**Oxley Solar Farm**

# **Amendment Report**

**November 2022**

**Project Number: 21-393**

Figure 3-2 Comparison of changes made between the EIS's Development footprint and the now refined Development footprint.

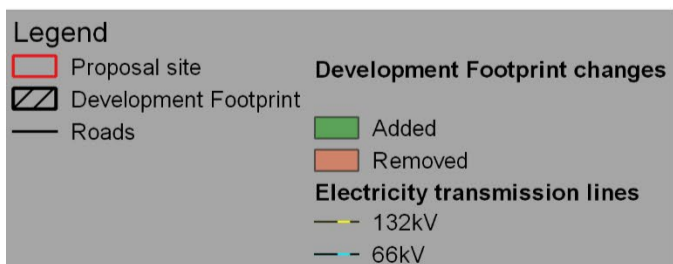
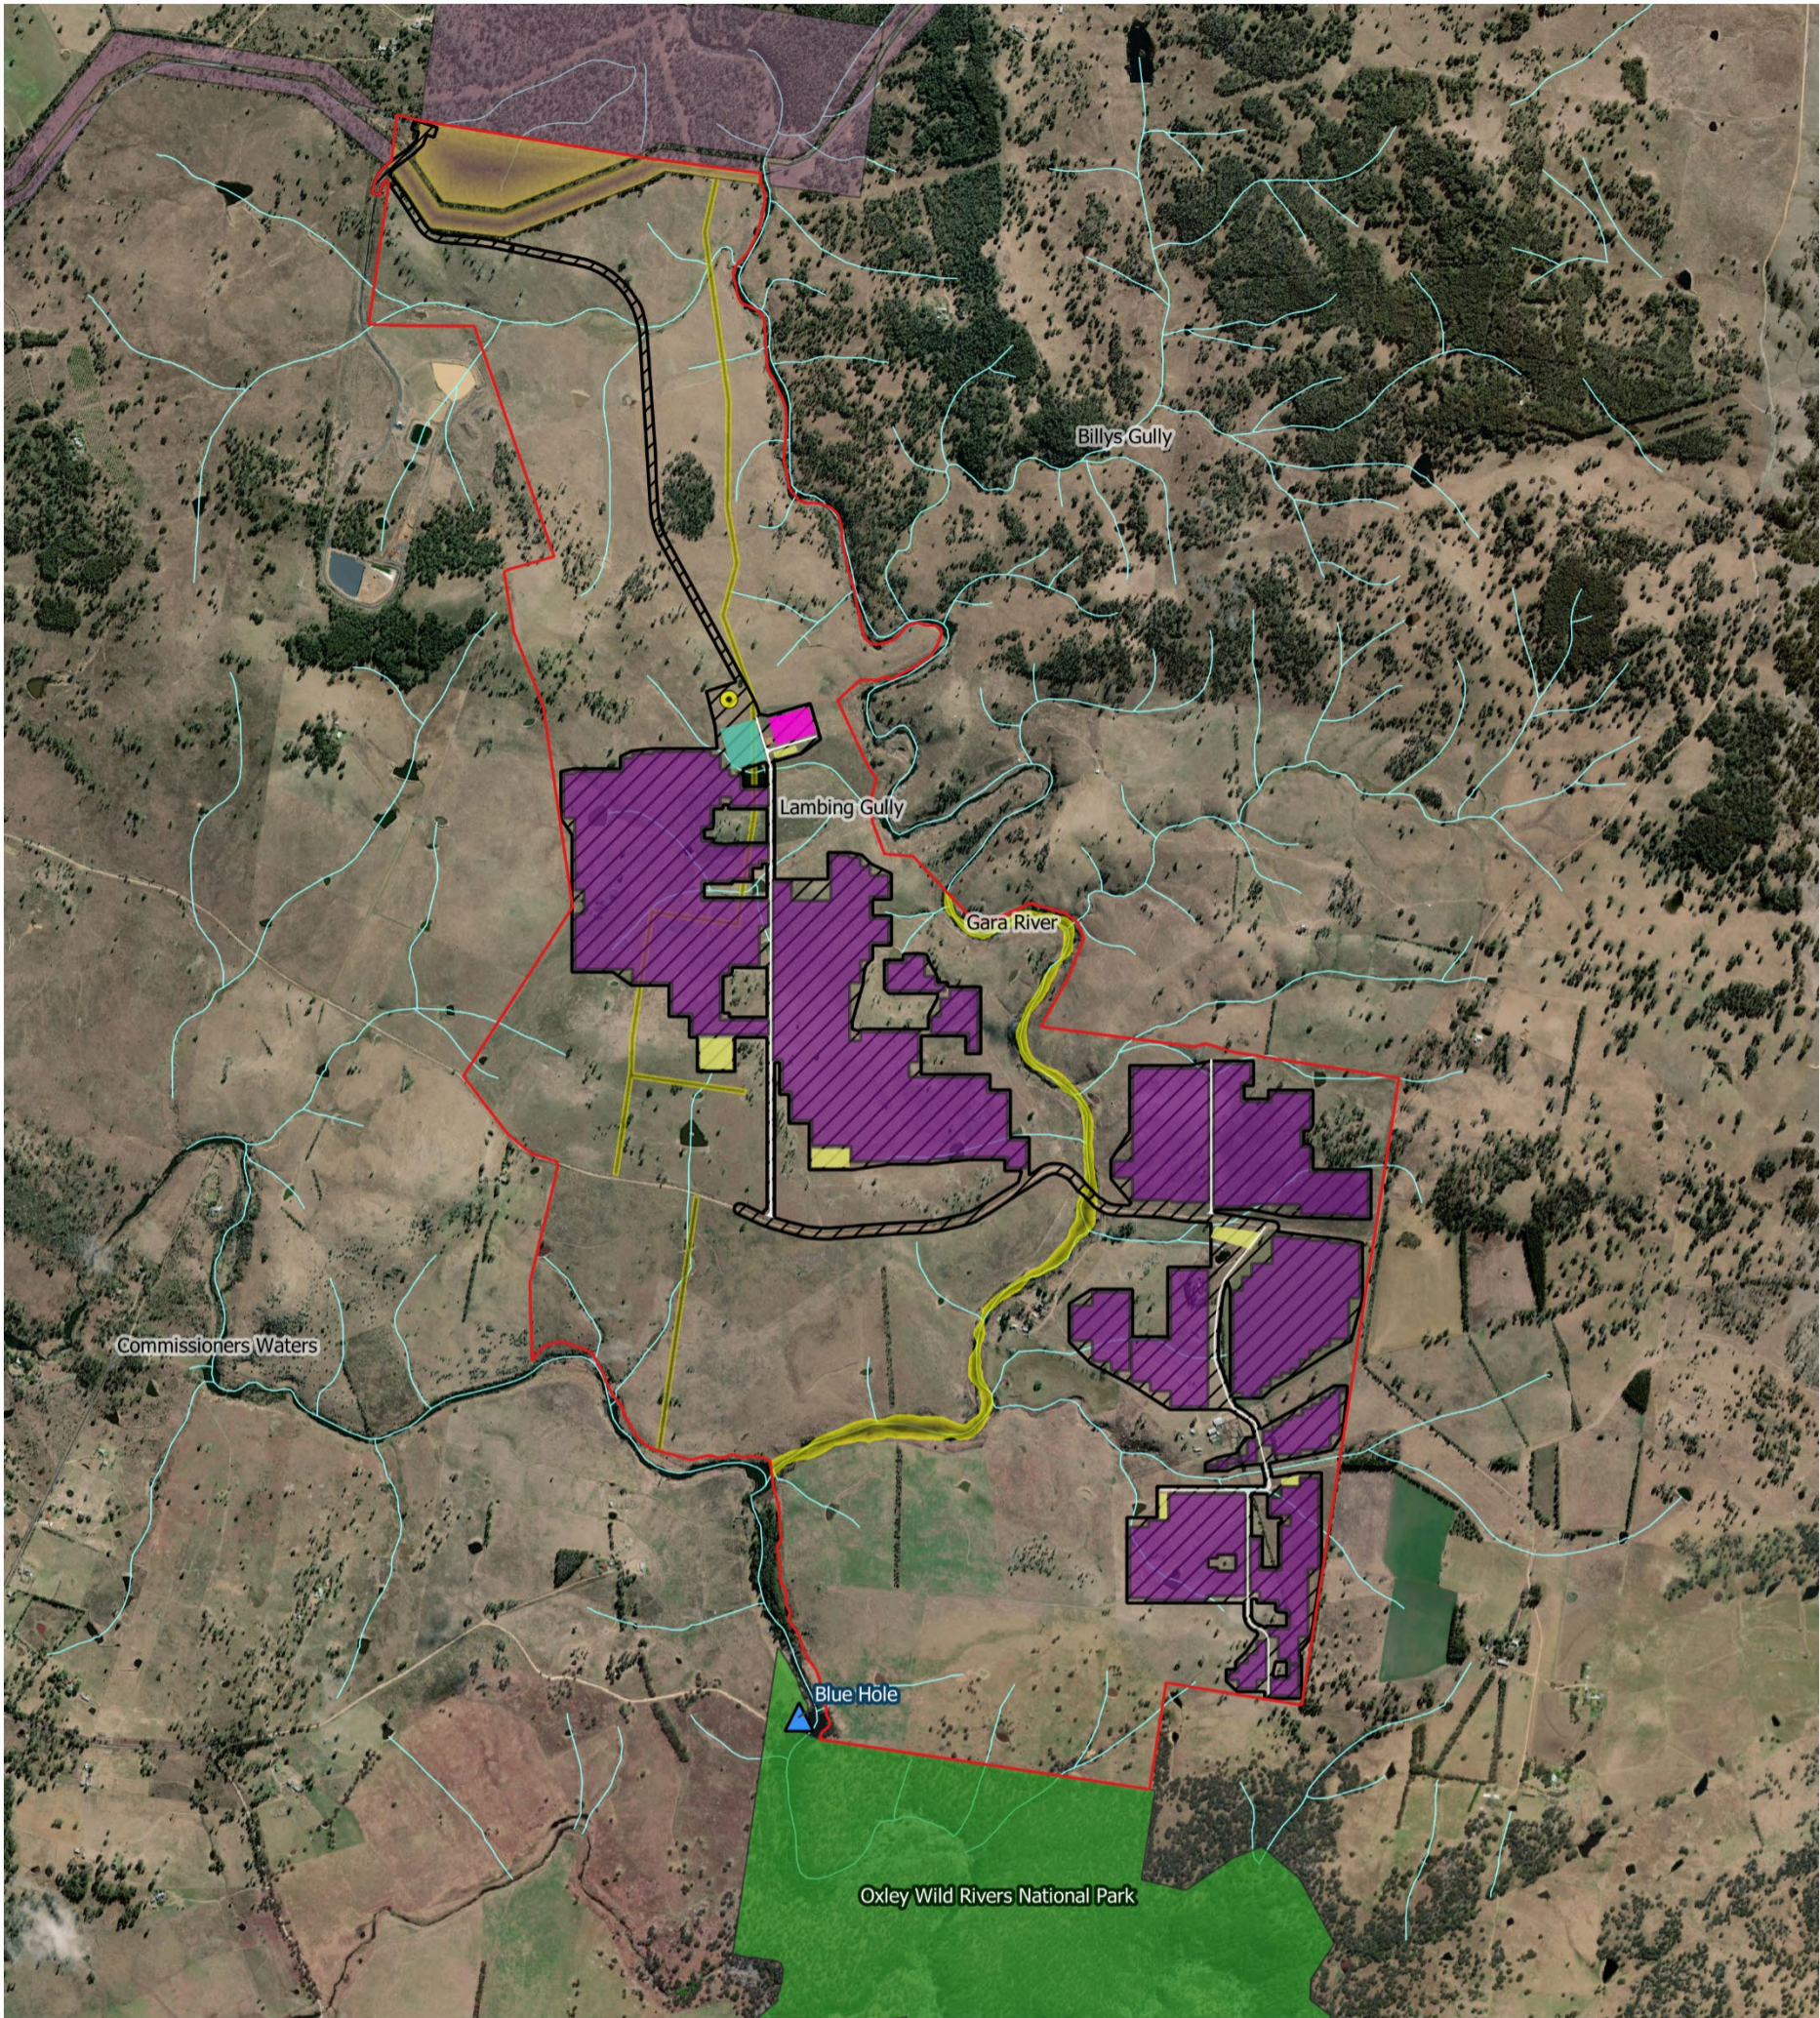
The changes detailed in full in Appendix A (an updated Proposal description) and shown in: Figure 3-1, Figure 3-2 and Figure 3-3.

In response, the Proponent undertaken additional civil design work that supports a much reduced Development footprint that still provides for sufficient flexibility in the detailed design stage that will occur closer to construction.

Figure 3-6 Indicative area to be subdivided from Lot 2 DP1206469 and Lot 5 DP253346

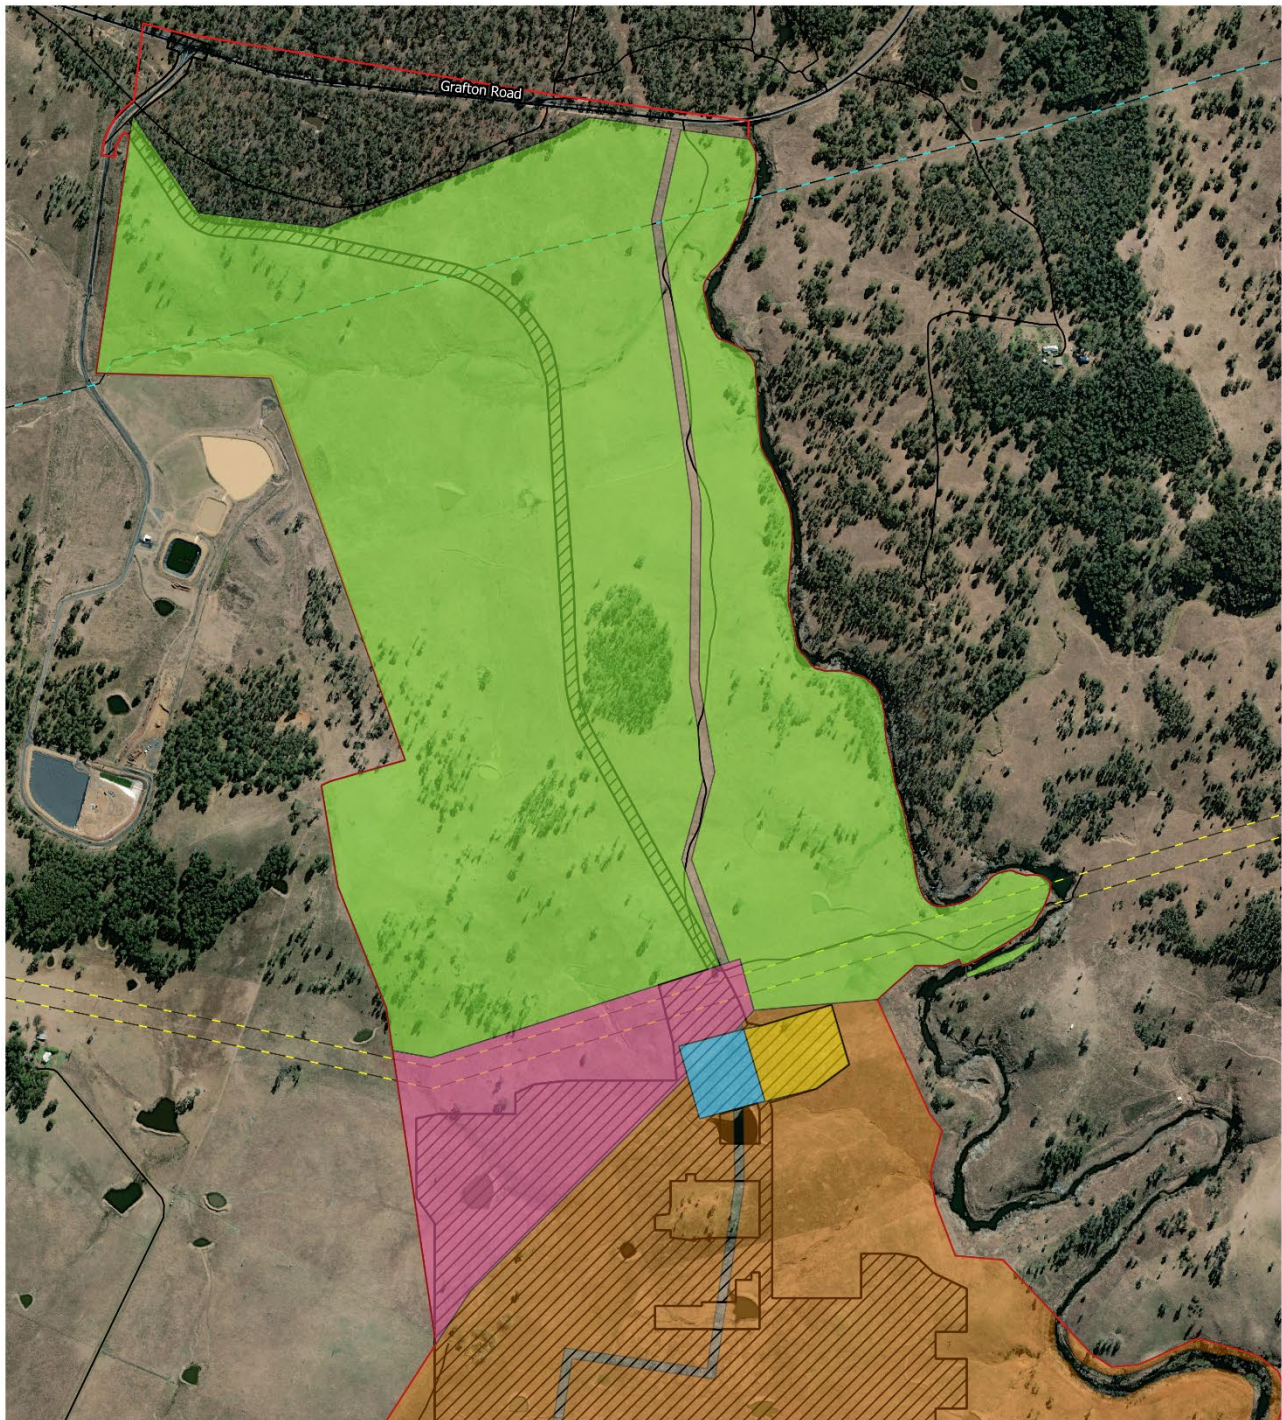
Boundaries of both Lot 2 DP1206469 and Lot 5 DP253346 would be modified by the proposed subdivision. Figure 3-5 shows the lots within and surrounding the Proposal site. The indicative subdivision of the site is indicated in Figure 3-6. The areas have been shown as:

- Lot A, residual agricultural land, about 208ha, to be retained by the existing landowner.
- Lot B, to enable connection to 132kV easement, about 26.5ha, to be incorporated into an expanded Lot 5 DP253346.
- Lot C, substation, about 2.4ha.
- Lot D, solar farm, about 668ha.
- Lot E, BESS, about 3ha.

Figure 6-1 Updated Category 1 land mapping, reflecting BCD consultation.

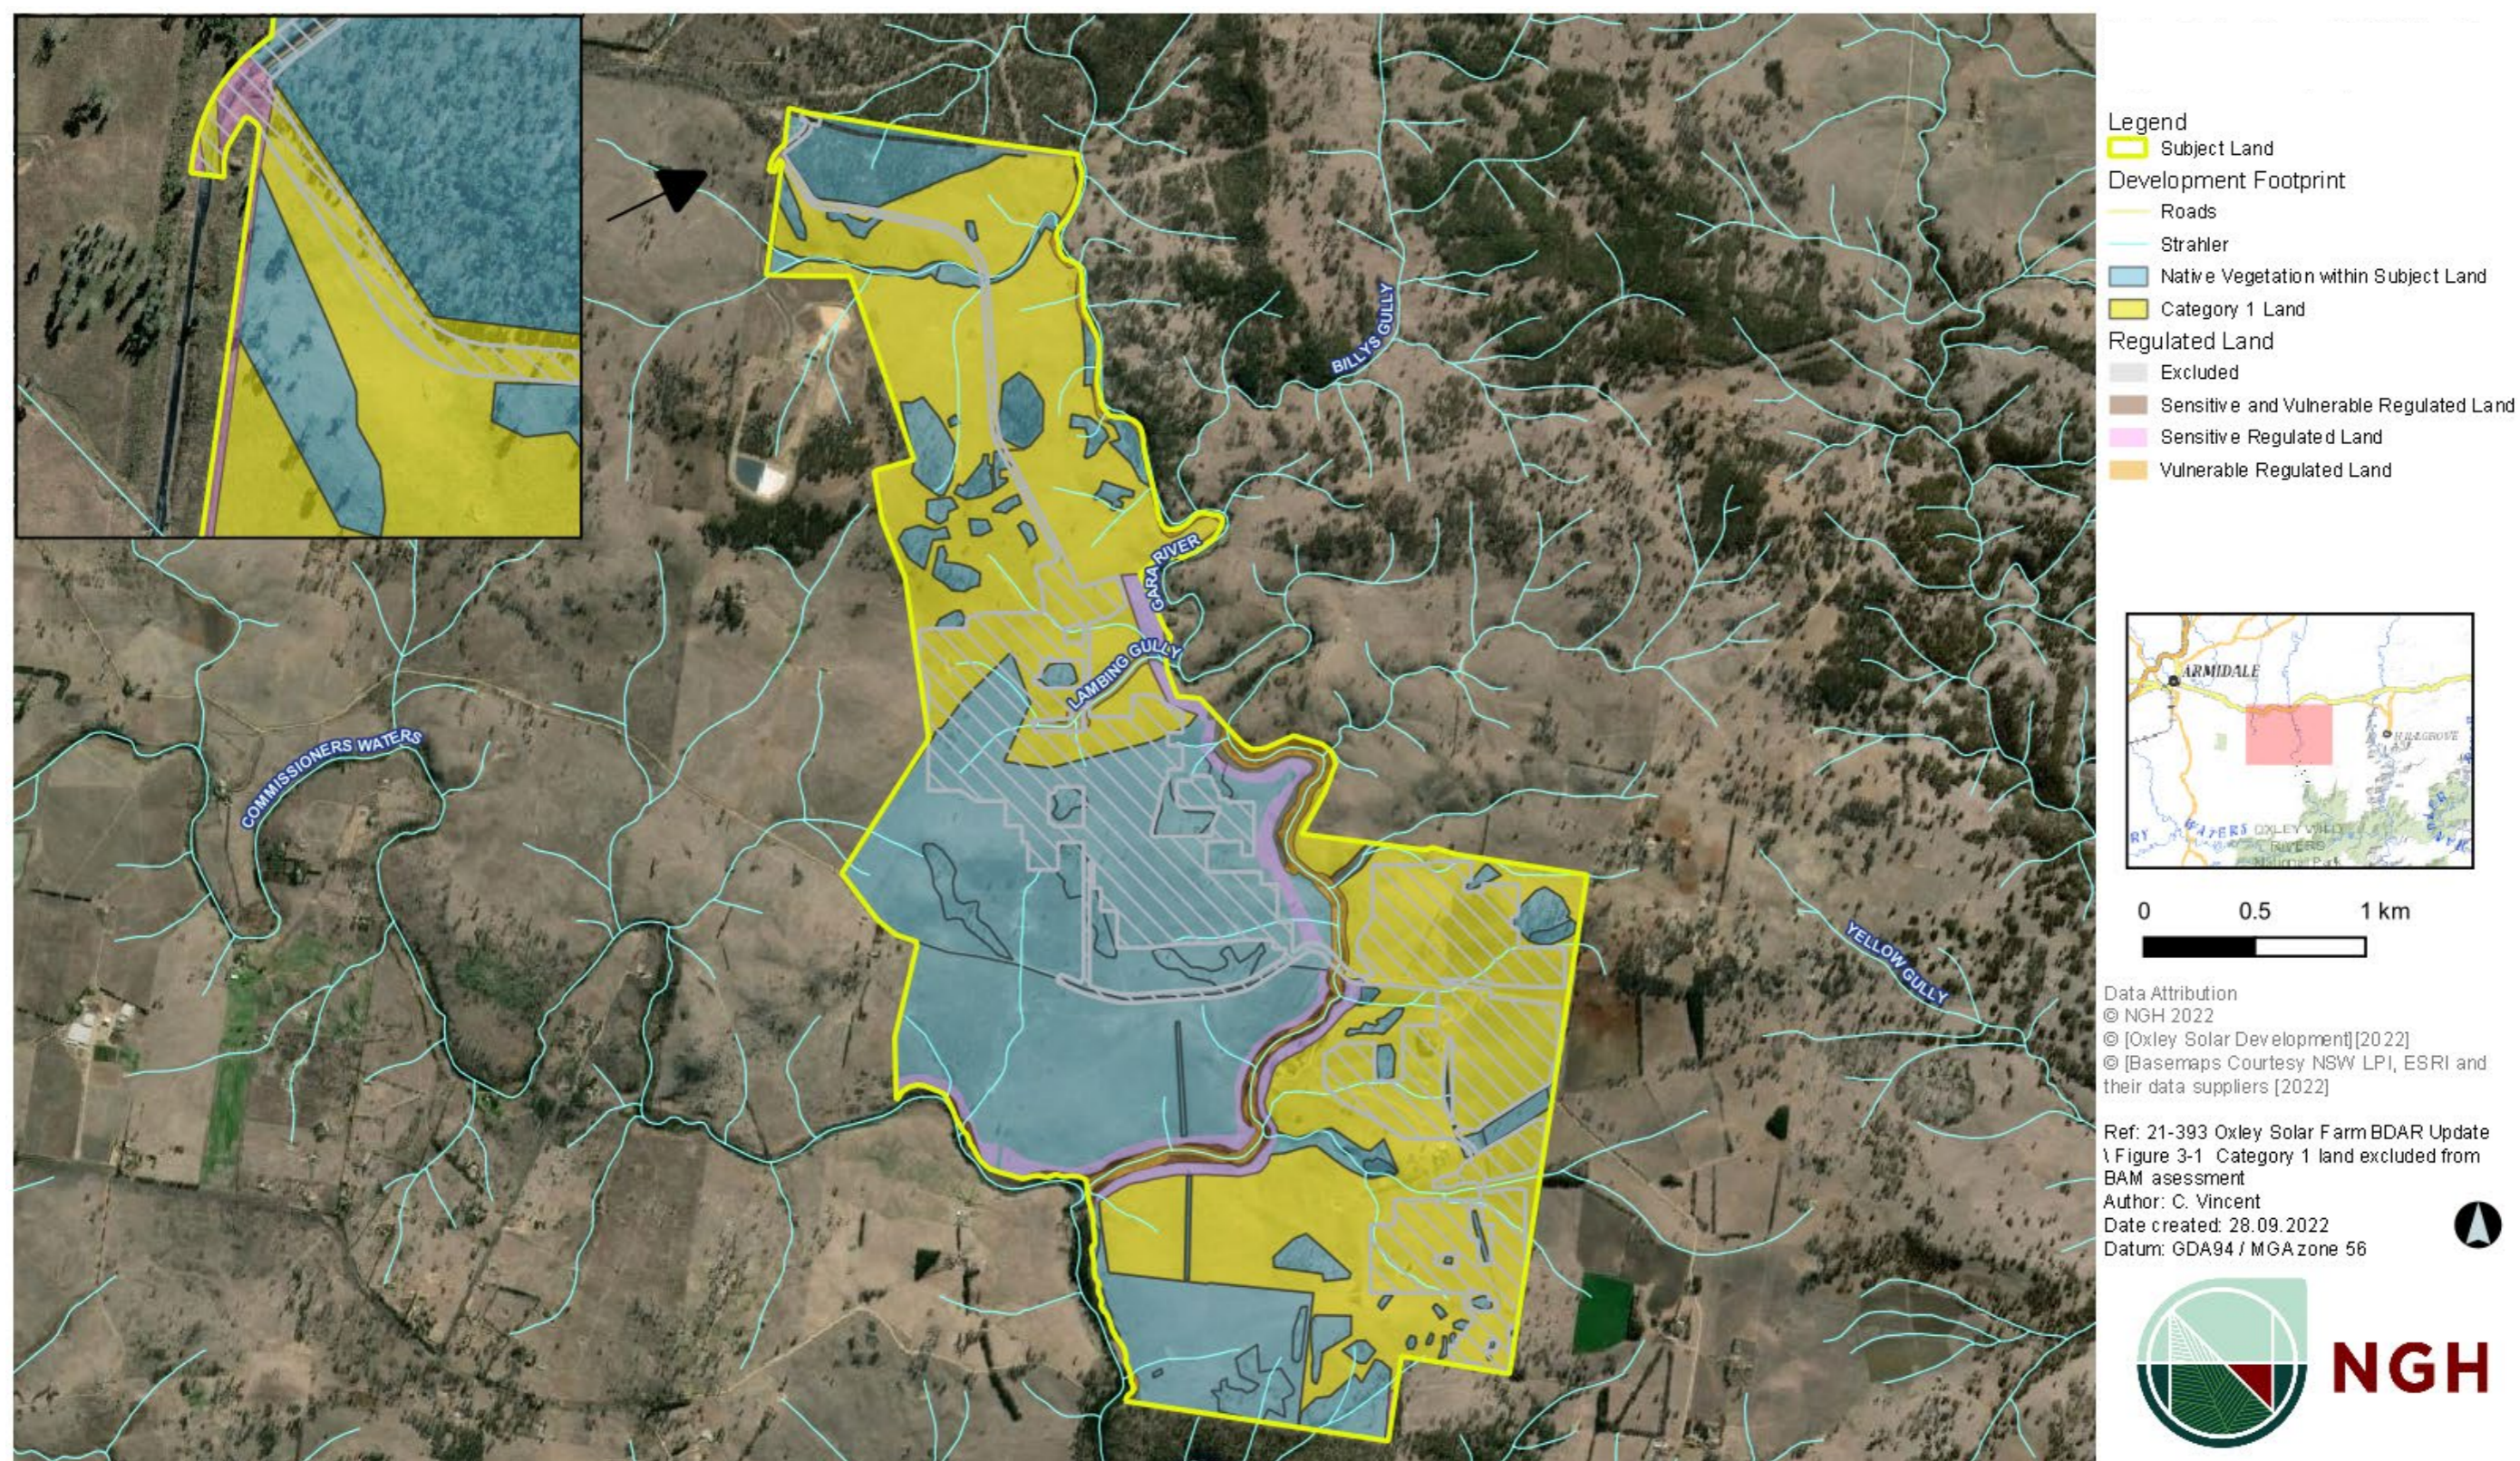
Furthermore, as BCD did not endorse all areas proposed to be classified as Category 1 Land (historically cultivated land thereby exempt from most aspects of the biodiversity assessment), the Category 1 mapping was updated in BDAR V3. BCD stated in their submission to BDAR v2.2 that the area between Gara Road and Gara River should not be classified as Category 1 land and should be assessed. This has now been updated in BDAR v3. The Proponent elected to remove panels from most of these areas.
